# Imperial Valley College

## Americans with Disabilities Act Facilities Evaluation

# Americans with Disabilities Act Facilities Evaluation

SHEET 54

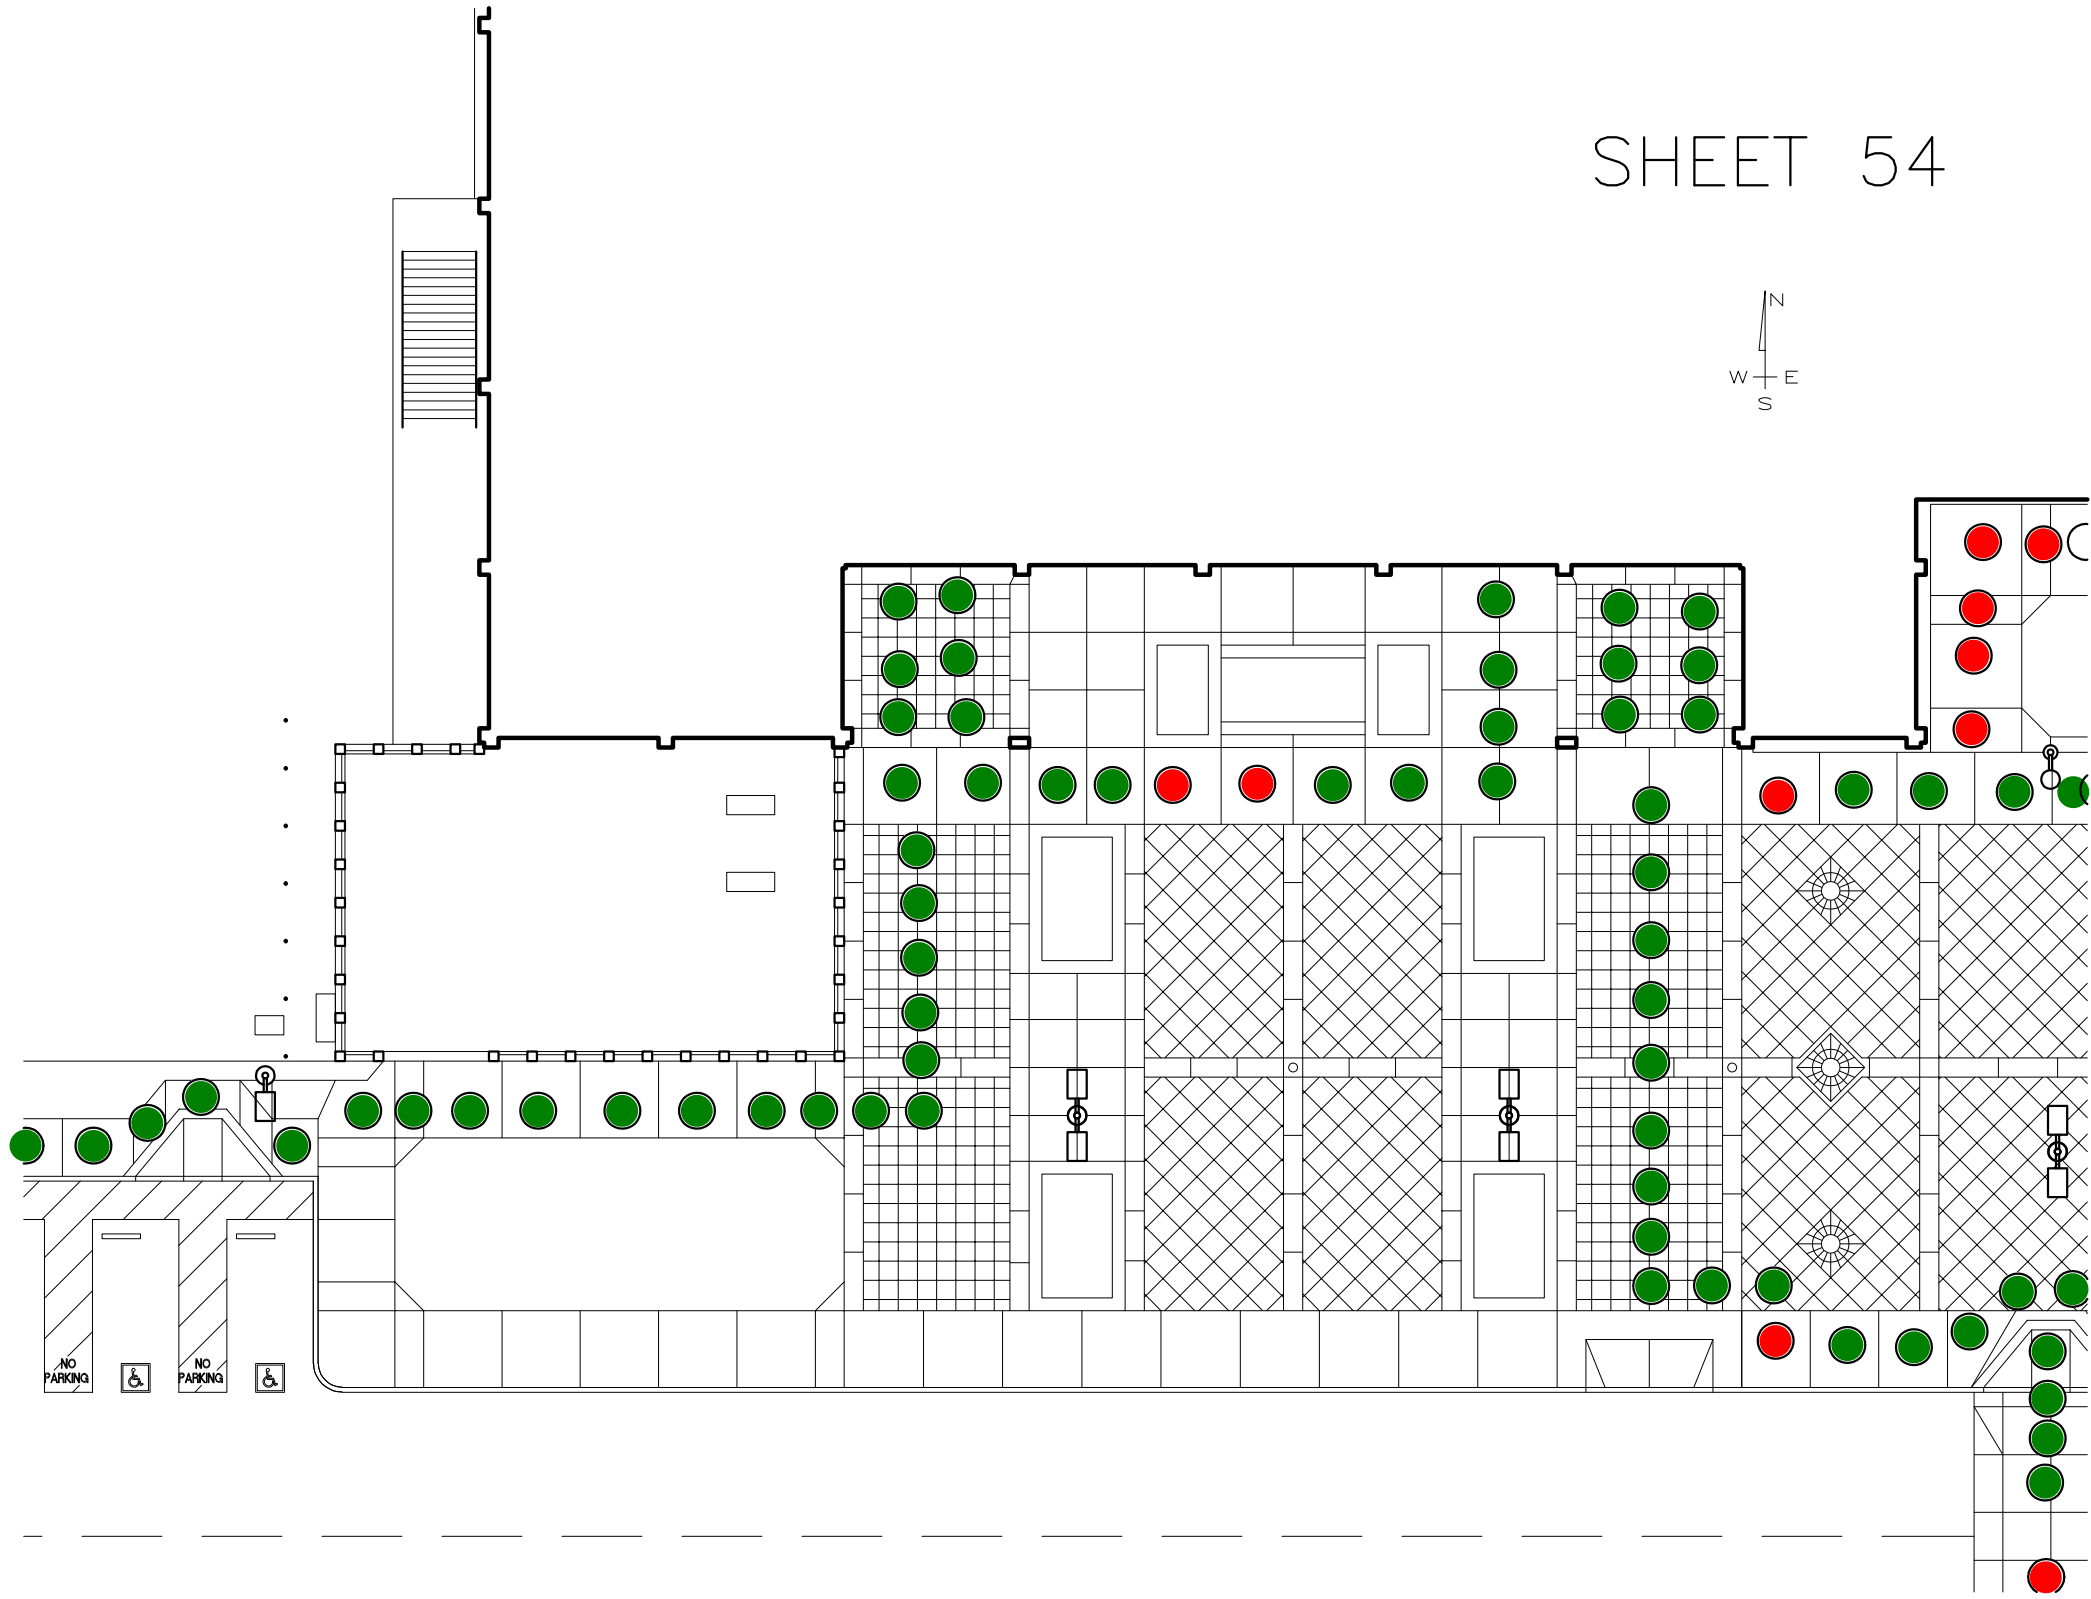
- Ramp south of Building 3800: Compliant.
    - Handrails of Ramp: Compliant.
  - Sheet 54: Long crack across curb ramp into accessible parking, some cracking, wear, and gaping along expansion joints, various instances of bad slope.

SHEET 56

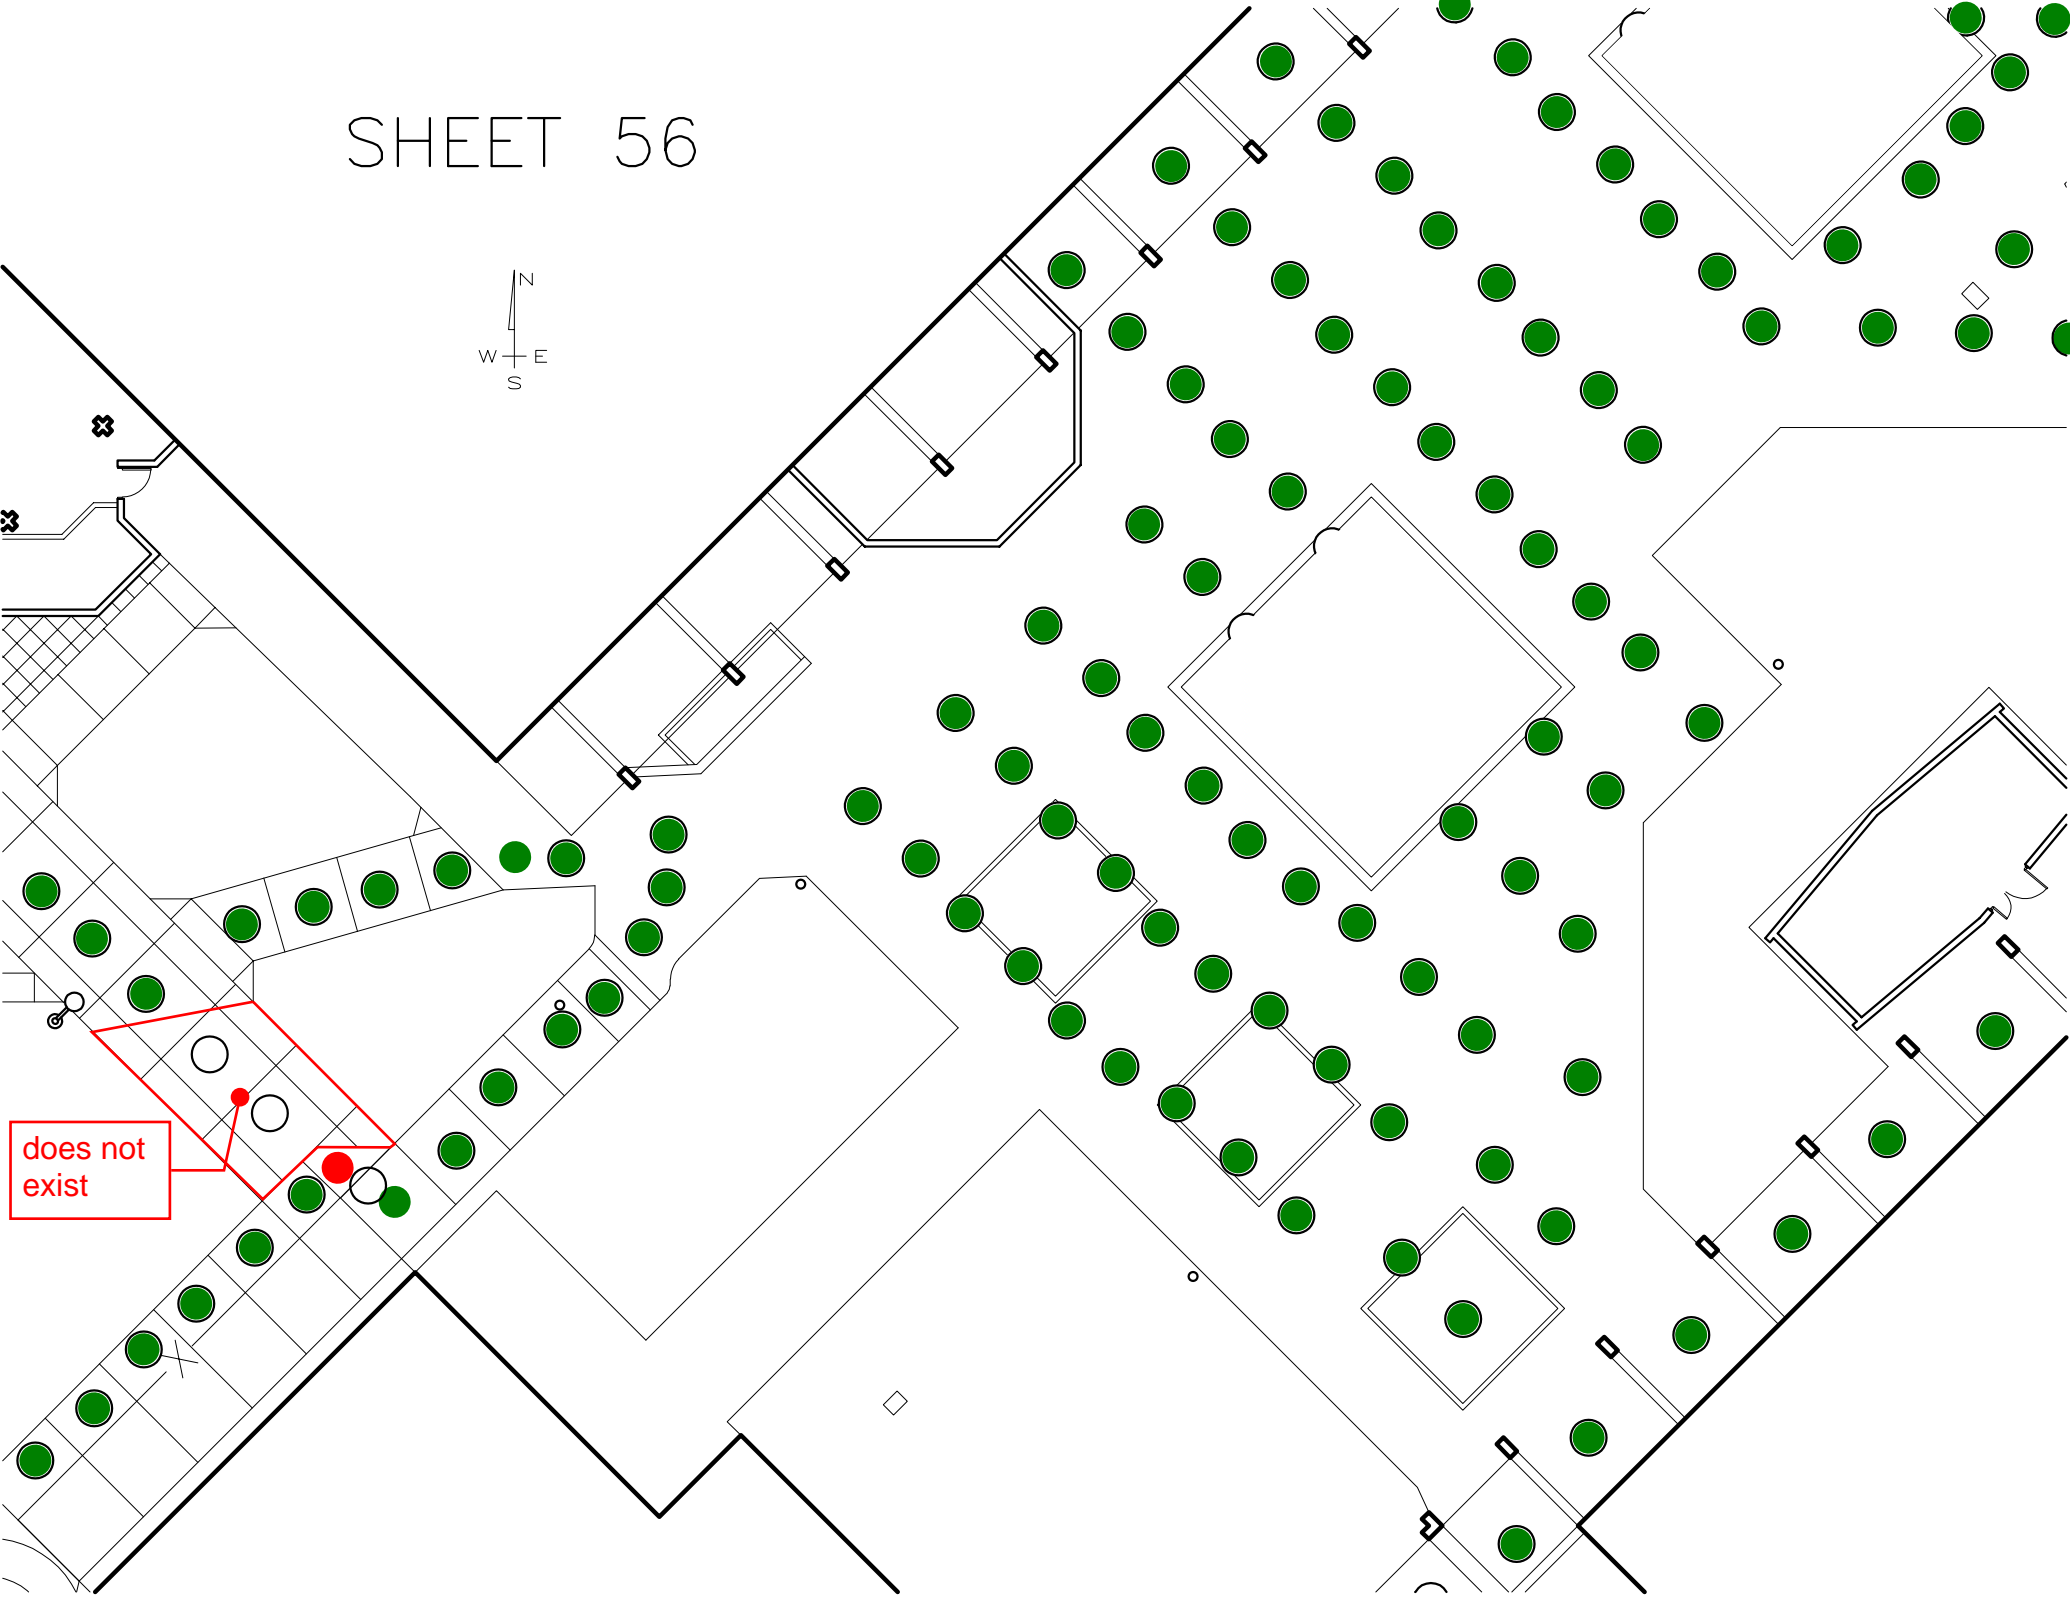
- Sheet 56: Large cracking across stretches of sidewalk, and uneven expansion joints causing differences in elevation, one small section of pathway with bad slope.

SHEET 57

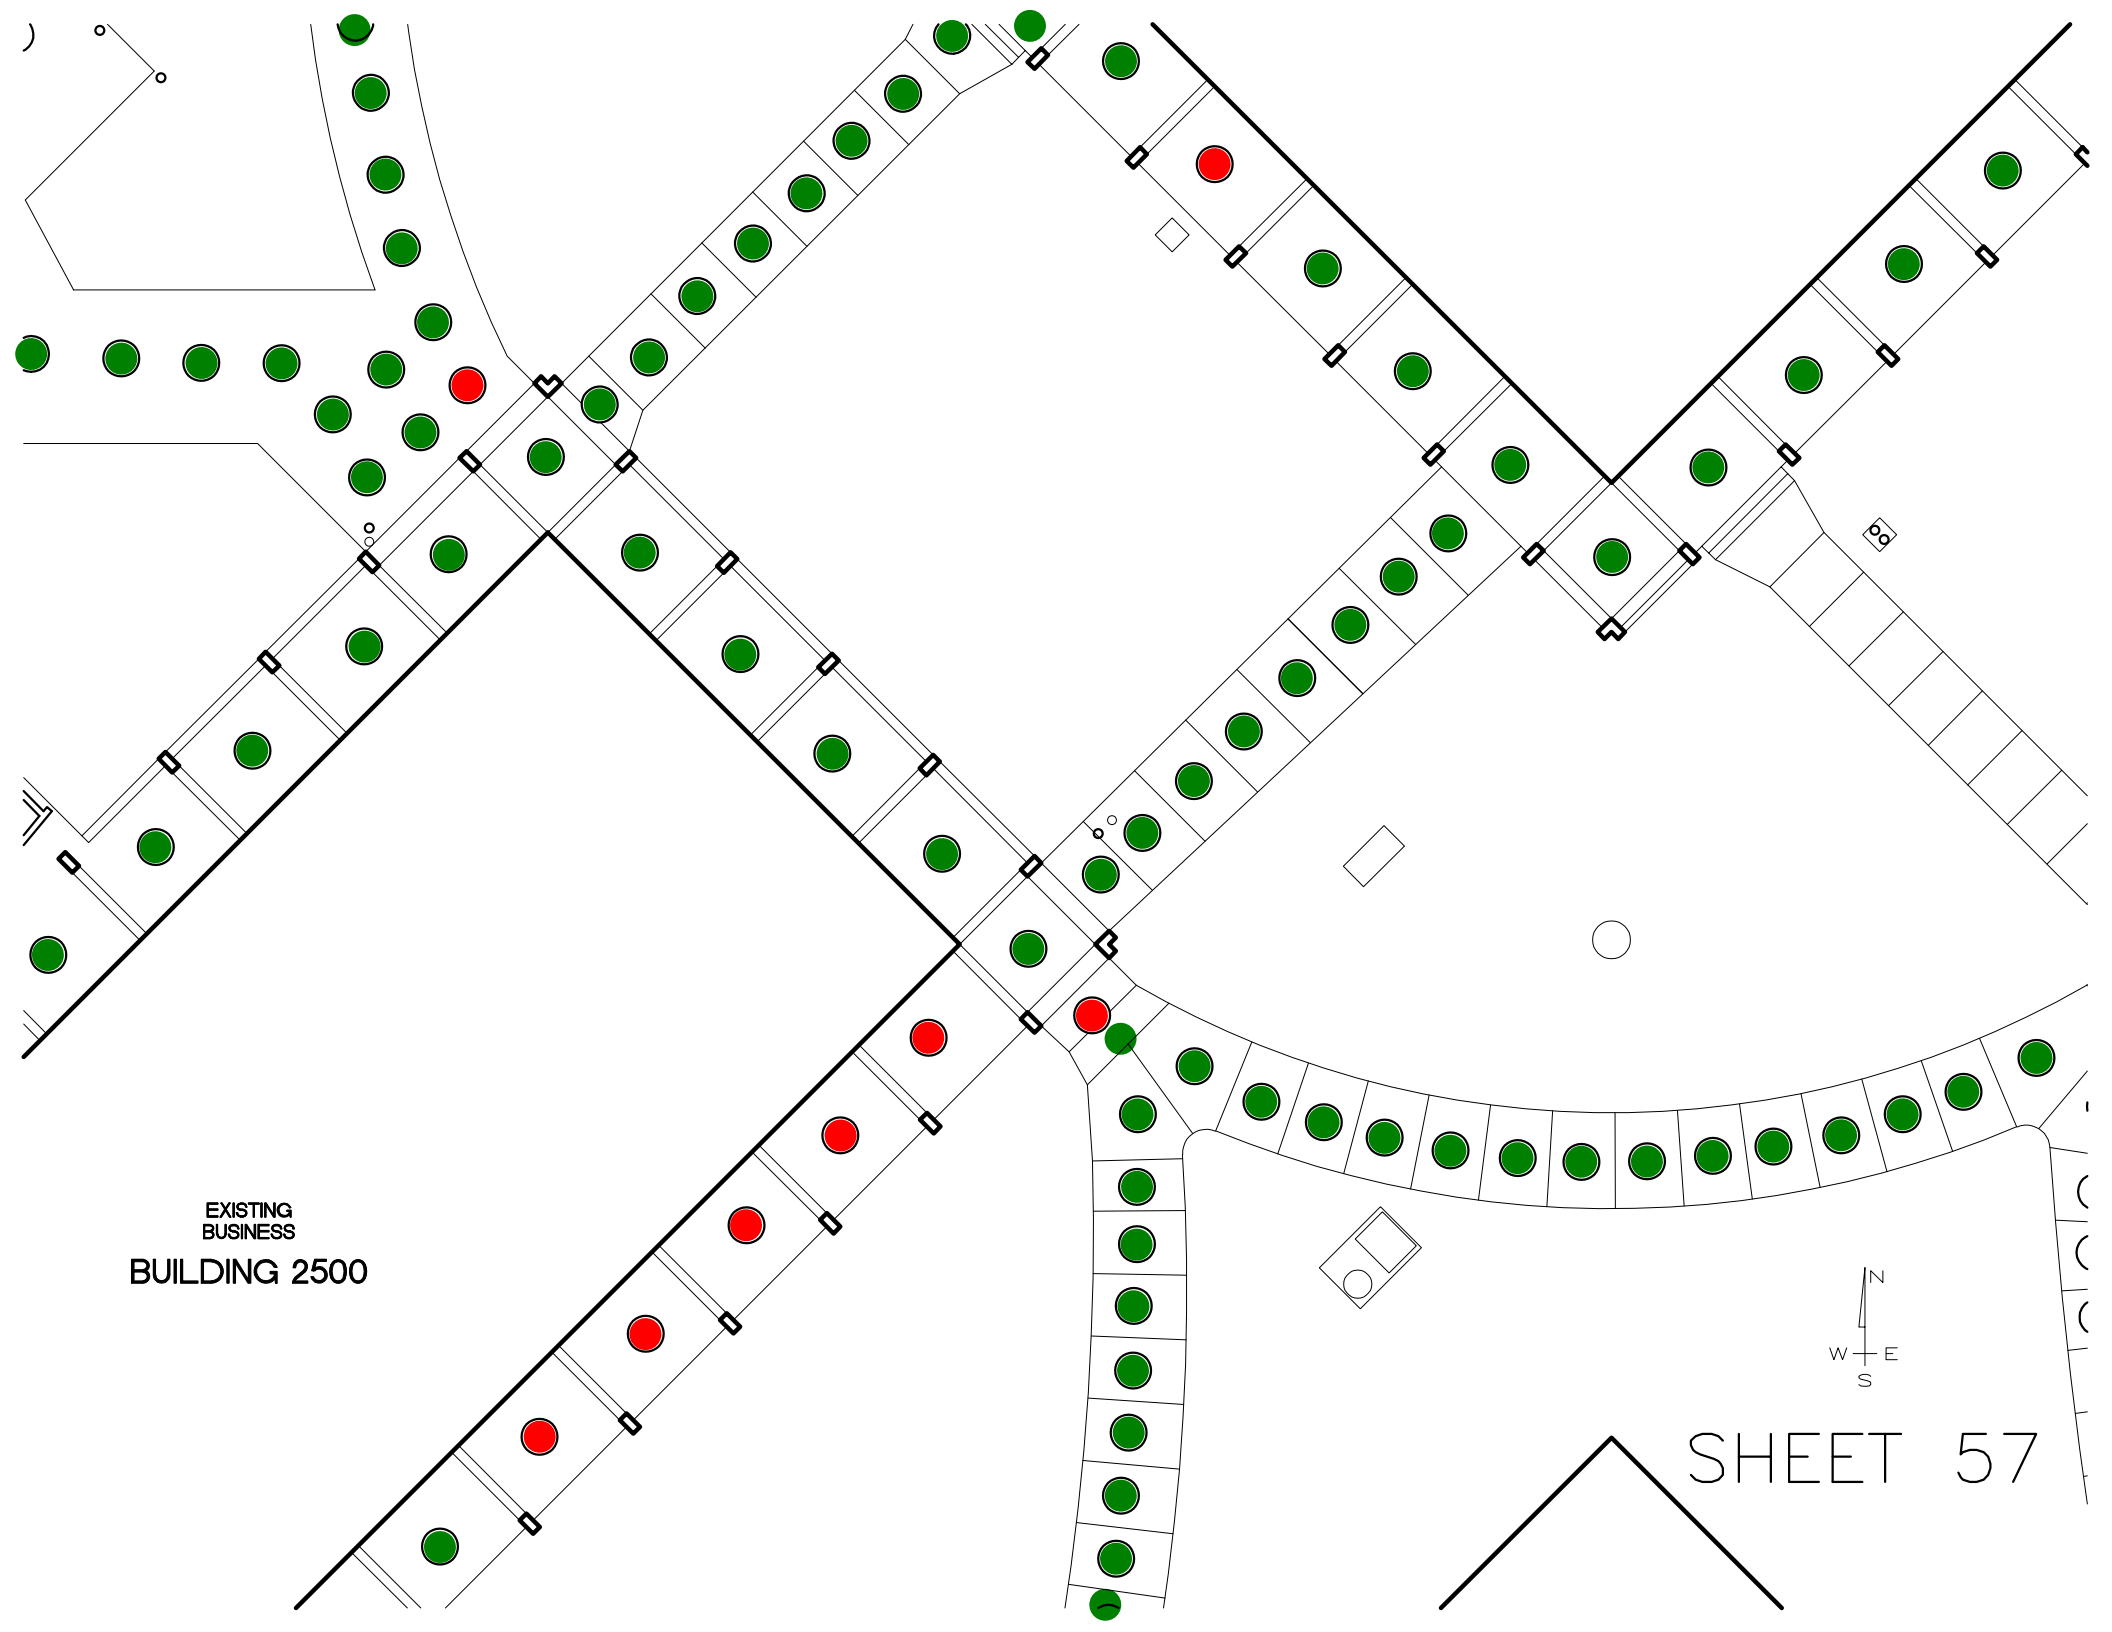
- Sheet 57: Long cracks across multiple sections of concrete pathways, holes and uneven concrete along expansion joints, severe cracking of concrete at bottom of steps towards buildings, and various instances of bad slope on the sidewalk.
